# HISTORIC LANDMARKS COMMISSION

**August 10, 2017**

Subject: **REQUEST FOR CERTIFICATE OF APPROPRIATENESS HC-2017-00027**, submitted by Linda Wahab, property owner, for exterior alterations and site modifications at property located at 122 South Broad Street. The property is further identified as Zoning Map 34G16, Block (6)A, Parcel 14A\*15, Suffolk Voting Borough, zoned RM, Residential Medium, zoning district, and HC, Historic Conservation Overlay District.

## STAFF REPORT

Proposed handrail style:

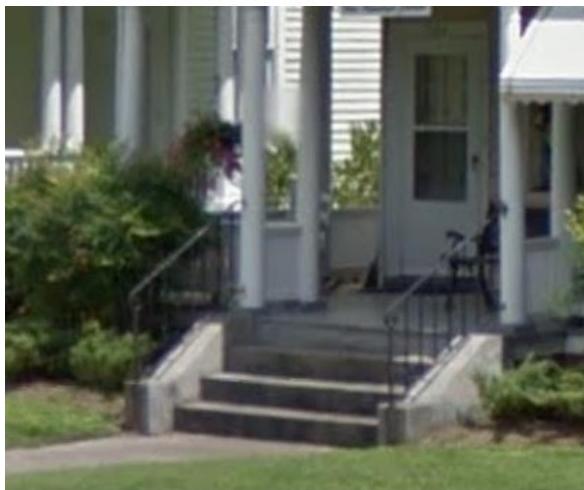
Handrails are proposed to be added to the existing front steps and the newly proposed left and right side steps. The applicant provided this example image below.

New metal handrails shall consist of a modest style that is consistent with other approved handrails in the Historic District. The black metal handrails at 112 and 116 South Broad Street, which consist of straight balusters and scrolled ends, are appropriate for the subject property as they will blend into their surroundings and not impact the historical integrity of the home. (The handrail design proposed by the applicant using is not appropriate.)

4. Install metal handrails on each set of steps on the wrap-around porch. The handrails shall substantially conform to the black metal handrails at 112 and 116 South Broad Street, which consist of straight balusters and scrolled ends.

Area where new section of privacy fencing is proposed:

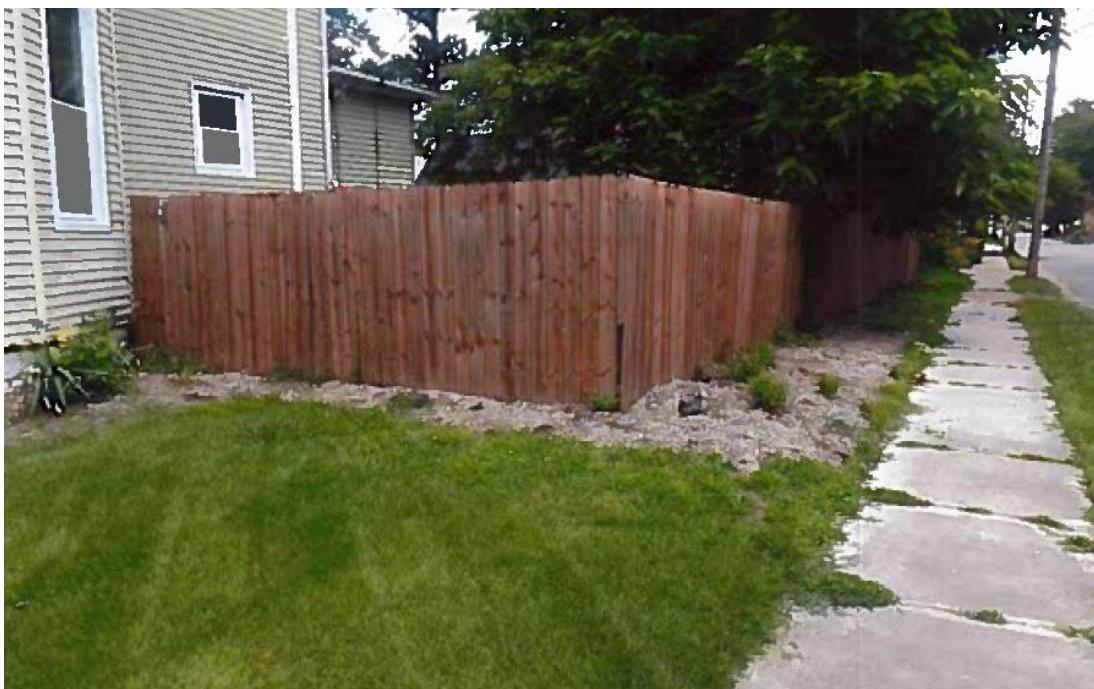
The privacy fence is proposed to be installed in front of the AC unit; therefore, the AC unit would not be visible from Broad Street. The fence will adjoin the existing fencing on the left.

1. Install a new section of six (6) foot tall wooden privacy fencing on the north side of the property, as indicated on the applicant's survey. The fence must match the height, materials, style, and color of the existing privacy fencing on the property. The "finished" side of the fence must face outwards.

**Proposed Privacy Fence Design:**

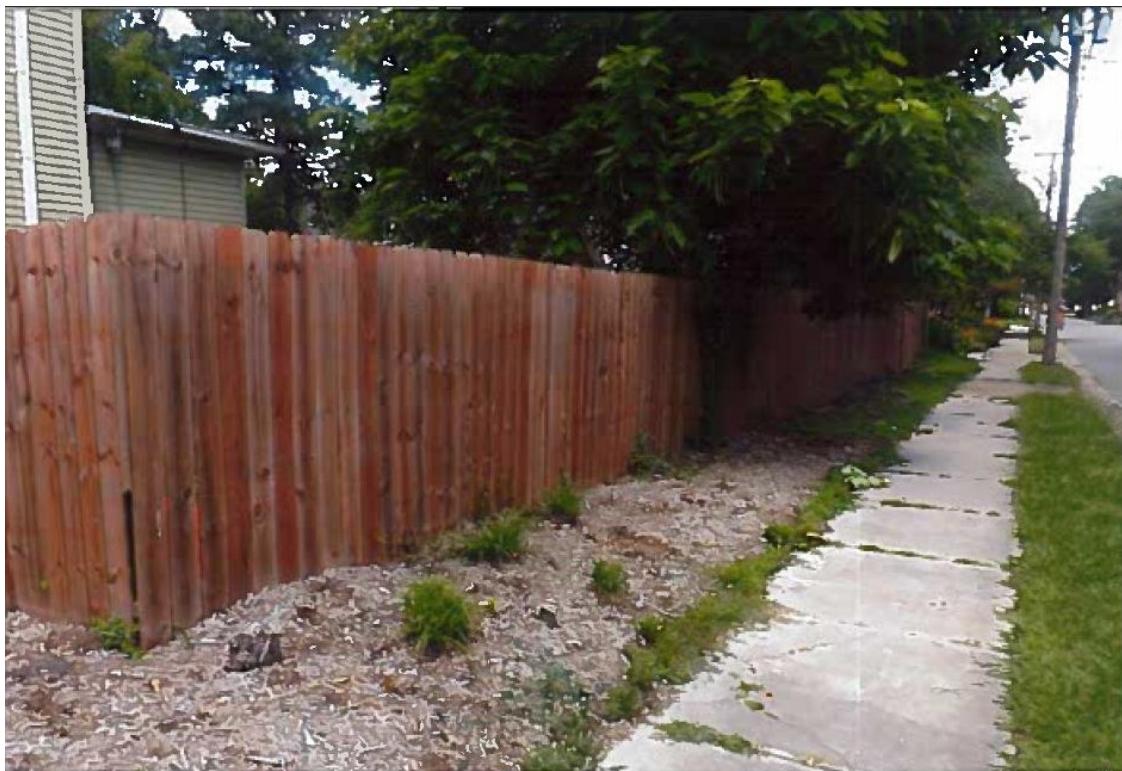
Match the new section of fencing with the existing privacy fence on the Smith Street side of the property, as shown below.
